Proposal by Roberto Macchi

I had a chat with Marianna on the BRAN contribution (BRAN39d058r1) to 802.16 for further contributing to WP9B for the finalisation of PDNRF.BWA. I understood that the document has been already submitted to 802.16 and you should discuss it at next meeting.

The following text is proposed to be inserted in Preliminary Draft New Recommendation ITU-R F.[9B/BWA], "Radio interface standards for broadband wireless access systems in the fixed service operating below 66 GHz" (Annex 6 to ITU-R Document 9B/83):

FIGURE 1

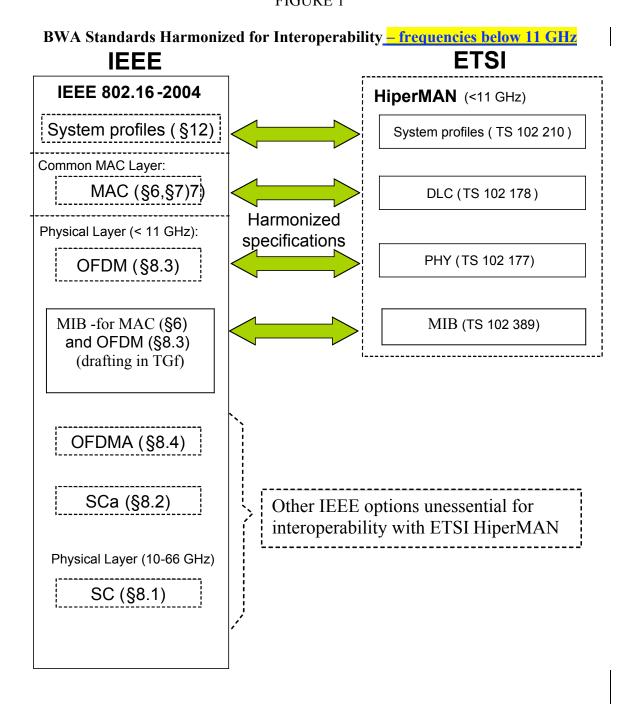
- 1) Figures 1 and 2 are a bit confusing showing both HA and HM, while they are specifically intended for "interoperability below 11 GHz" and "common elements above 11 GHz"; then I propose to edit them as in the attached document where I removed all HA in figure 1 and all HM in figure 2.
- 2) In Figure 2, I was also puzzled about the contradictory arrows showing FEC (is it common or not and to which extent??). In the attached document, besides removing the part relevant to HM, I have deleted the HA link with IEEE OFDM FEC because, even if true (and I think not), it is unessential and can cause only confusion unless a better clarification is done.
- 3) I have proposed few (highlighted) editorial changes in the text mainly in the introduction of Figures, for the same purpose of clarifying them.

Figure 1 shows the equivalency of the IEEE 802.16-2004 and ETSI HiperMAN and HiperAccess standards for bands below 11 GHz, while Figure 2 shows similarities between the IEEE 802.16-2004 and ETSI HiperACCESS.
